STAFF REPORT COVER SHEET

October 28, 2024

ATTACHMENT 01

Address	101 Maple Ave E	Case Number	947761
Meeting Date	10/28/2024	Applicant	Fairfax County, Maryam Mostamandi, Project Manager
Board/Commission	Town Council	Owner	Fairfax County Board of Supervisors
Existing Zoning	C-2 at the time of application AC currently	Existing Land Use	Governmental
Brief Summary of Requests	<ol style="list-style-type: none"> Request for approval of proposed Modifications of Requirements for front and rear yard setbacks, loading area, and tree canopy coverage. Request for approval of proposed landscape plans. 		
Site Improvements	The applicant proposes demolishing the existing library building and surface parking lot to construct a new library and parking garage.		
Size of Property	62,326 sf (1.43 acres)		
Public Notice Requirements:	<ul style="list-style-type: none"> Two signs were posted on the property on October 14, 2024, one on Maple Ave E and one on Center St S, with the dates of the Town Council meeting. Letters were sent on October 2, 2024, to adjacent, abutting, and immediately across-the-street property owners, agents, and occupants, and the subject property owners notifying them of the Pla

Figure 2: Proposed 10 ft front yard setback

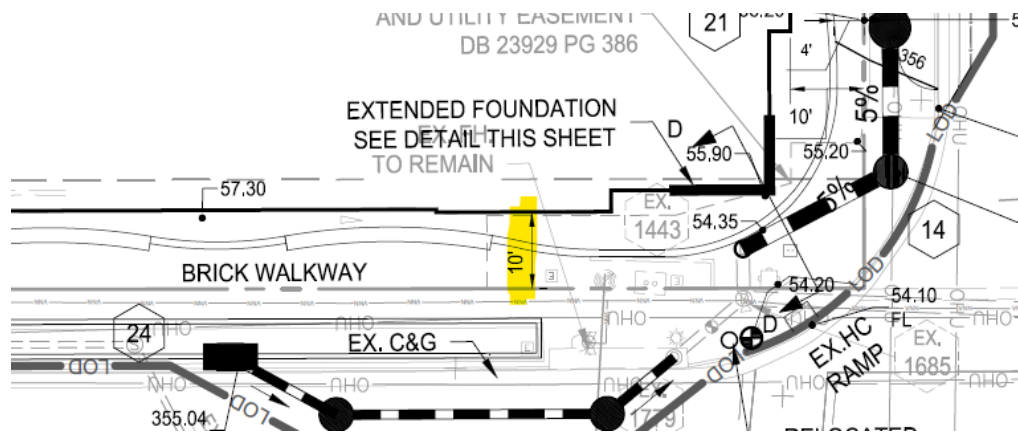
The applicant requests a modification of the 15' front yard setback to 10' from the front street line along Maple Avenue.

The applicant states that the modification is necessary for the new library to contain sufficient interior space to meet the needs of the community.

The existing library is set back 13' from the Maple Avenue E right-of-way and 20.7' from the Center Street S right-of-way. At the time of construction of the current building, the front was considered the side facing Center Street S. There was no required side setback along Maple Avenue E at the time, and the required front setback along Center Street S was 15'. The proposed modification would move the new building 3' closer to Maple Avenue E than the current building. Attachment 06 illustrates the current position of the sidewalk and building in relation to the property line, and also provides a comparison with the proposed changes.

Figure 3: Proposed rear yard setback with variable widths, with the narrowest point measuring 3 ft

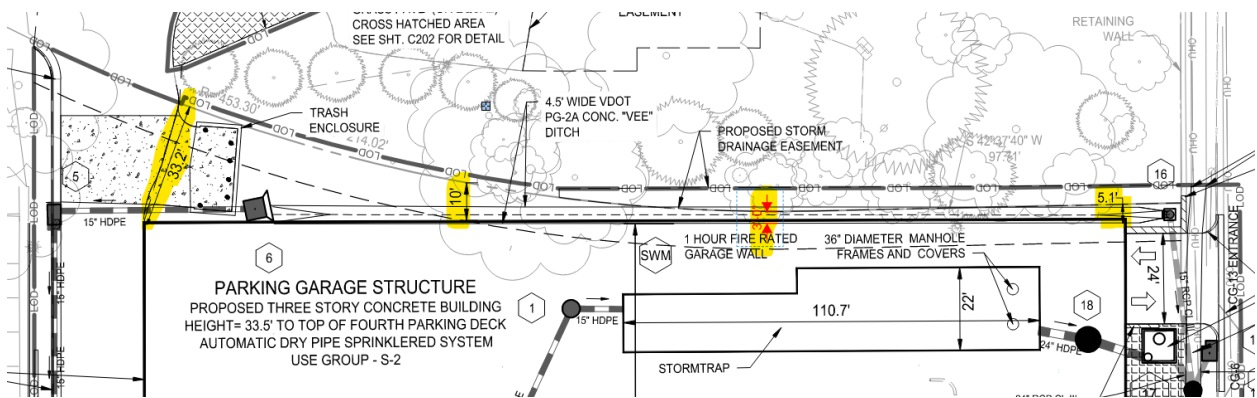
The applicant requests a modification of the 10' rear yard setback to 3' at its smallest dimension.

Due to a majority of the rear property line being curved, a modification is only necessary for the first 60% of its length, starting from Center Street S. The remaining 40% meets or exceeds the setback requirement. It is also important to note that the adjacent property owner most affected by this request is the Fairfax County School Board, as the property is currently utilized as the Vienna Elementary School.

Figure 4: Proposed landscape plan overlaid with proposed off-site easements plat.

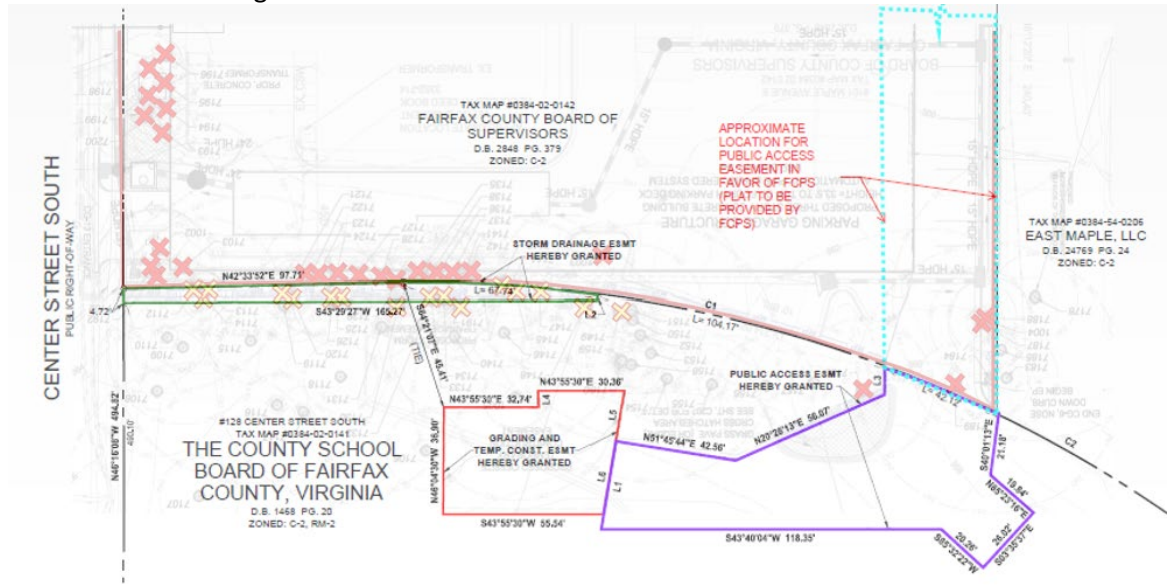
The applicant requests a modification of the 10% tree canopy requirement in the C-2 zone, seeking approval to provide only 4% coverage on this site.

The footprint of the parking garage and new library leaves limited space for tree planting that would meet the 10% canopy goal at 20-year maturity, as defined by the "Tree Preservation and Planting Guide" (2-2021). The new library design plans to remove and replace seven existing street trees and add shrubs along Maple Avenue. Additionally, four new street trees will be planted along Center Street’s utility strip to help mitigate the impact, but these trees, along with those on Maple Avenue, cannot count toward the 4% coverage since they are not on the property itself.

The Planning Commission and the Board of Architectural Review (BAR) have raised concerns about the low amount of tree canopy. The BAR specifically asked about trees being removed on the adjacent Vienna Elementary School property as part of the construction of the parking garage. Fairfax County (owner of the library site) holds off-site easements on the school property (owned by Fairfax County Public Schools) for storm drainage, grading, temporary construction, and public access. In response to the BAR’s concerns, the Fairfax County Department of Public Works and Environmental Services (DPWES) confirmed their efforts to maintain and enhance the town’s tree canopy, through the following response to Planning Commission and BAR comments:

Although the new plantings will not count toward the on-site tree canopy requirement, they will still contribute to the overall landscape and will benefit the project as a whole. Figure 4 below shows the location of each tree to be removed with an X. The storm drainage easement is shown below with a green line.

“The Fairfax County Department of Public Works and Environmental Services’ (DPWES) development plan has addressed the Town of Vienna BAR’s desire to maintain and improve the tree canopy in the Town. For the area impacted by the stormwater easement along the southeast property boundary, DPWES will be clearing the trees and plantings, including invasive species. In addition, DPWES will be replacing this loss of trees/plantings by planting new trees along the same side but further north where the area is not restricted by the foundation of the future garage. DPWES will work with the Town of Vienna’s arborist to select appropriate trees and greenery in these areas to ensure they are sustainable long term and will shield the view of the rear area from Center Street. DPWES has advised Fairfax County Public Schools (FCPS) of the potential impact of the construction in the adjacent FCPS-owned landscaped areas and will

continue to coordinate with regard to FCPS’s management, maintenance and clearing of the overgrowth on the school property.”

Figure 6: Proposed 15'x35' loading area

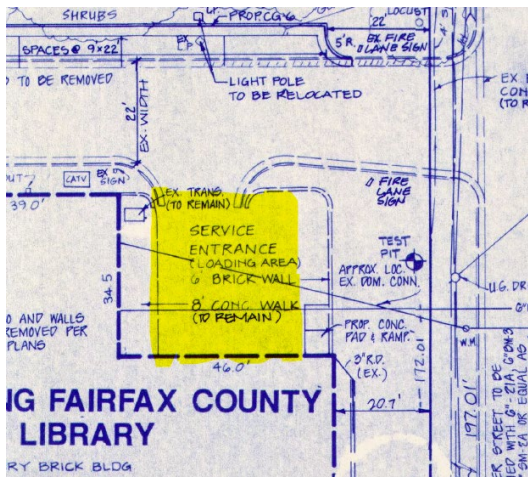
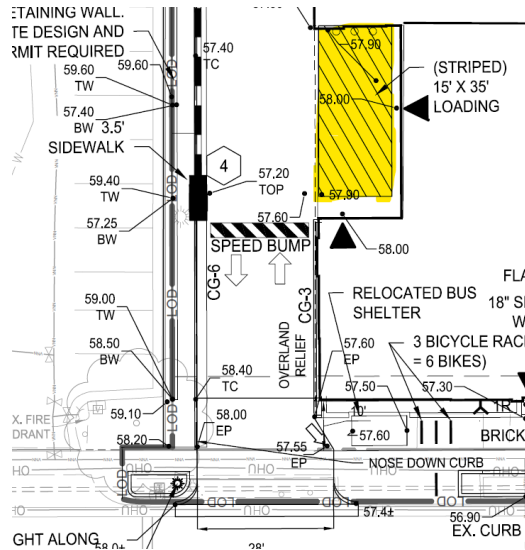
The applicant requests a modification of the loading space from the 25’ by 90’ area required ($261.95' \text{ divided by } 50' = 6 \text{ times } 15' = 90'$) to allow for a 15’ x 35’ loading space.

The reduced loading area is requested to better accommodate the specific operational needs of the proposed library use. The reduced dimensions are sufficient for the type and frequency of deliveries expected at the site while also allowing for a more efficient site layout and increased usability of the remaining space for other essential functions. Although this application is being evaluated under the previous zoning code, it is important to highlight that the proposed loading space exceeds the new requirement of a 25-foot by 15-foot area set forth in the updated code.

Figure 7: Proposed front yard landscape calculations

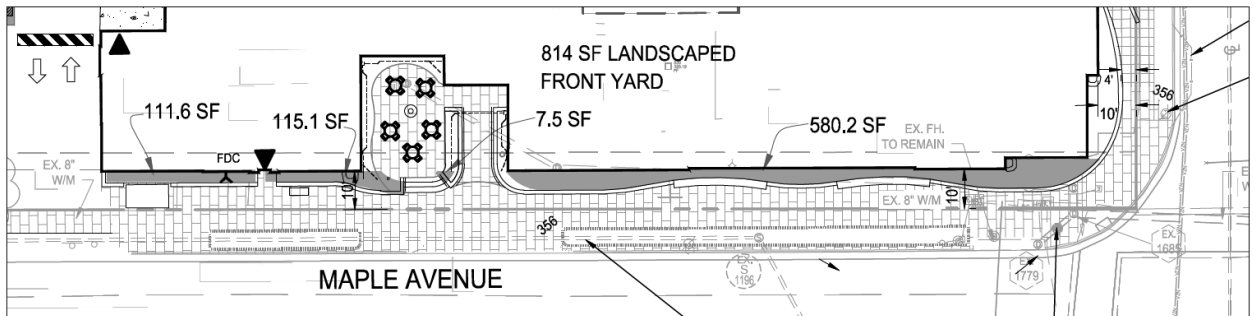
The zoning code's only landscaping regulations require that 25% of the front yard be landscaped and that the landscaping be properly maintained. If the modification of the front yard is approved at 10 feet, then the proposed landscaping meets the required 25% coverage.

Figure 9: Proposed conditions showing gap in planters as it exists today continuing in previous design plans.

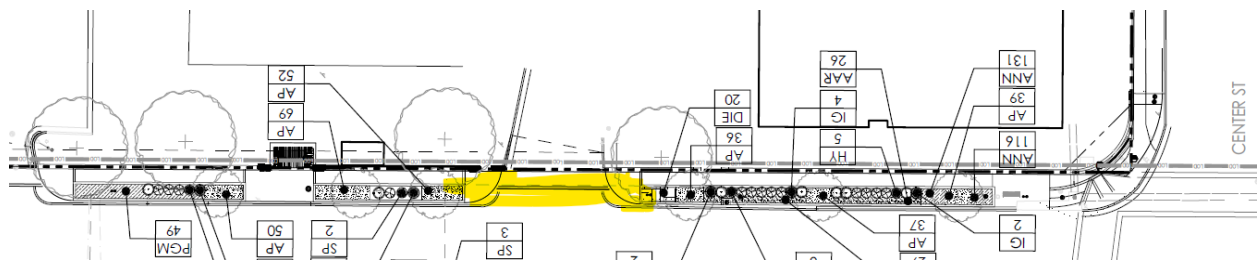
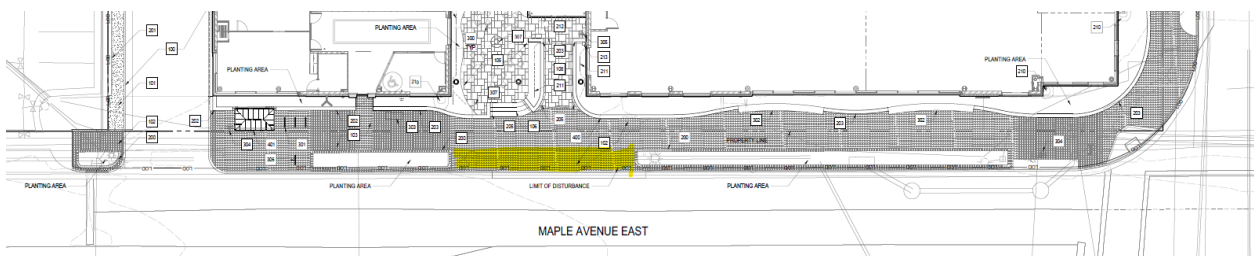
Both the Planning Commission and the BAR raised concerns about a gap in the planting buffer along Maple Avenue E, noting that it could encourage drivers to pull over and drop off passengers directly in front of the library's main entrance (See Figure 9). Fairfax County clarified that the gap was not intentional but exists because it aligns with the current parking lot entrance (See Figure 8). They are willing to address the issue by extending the planter to fill the space and will update the design drawings accordingly.
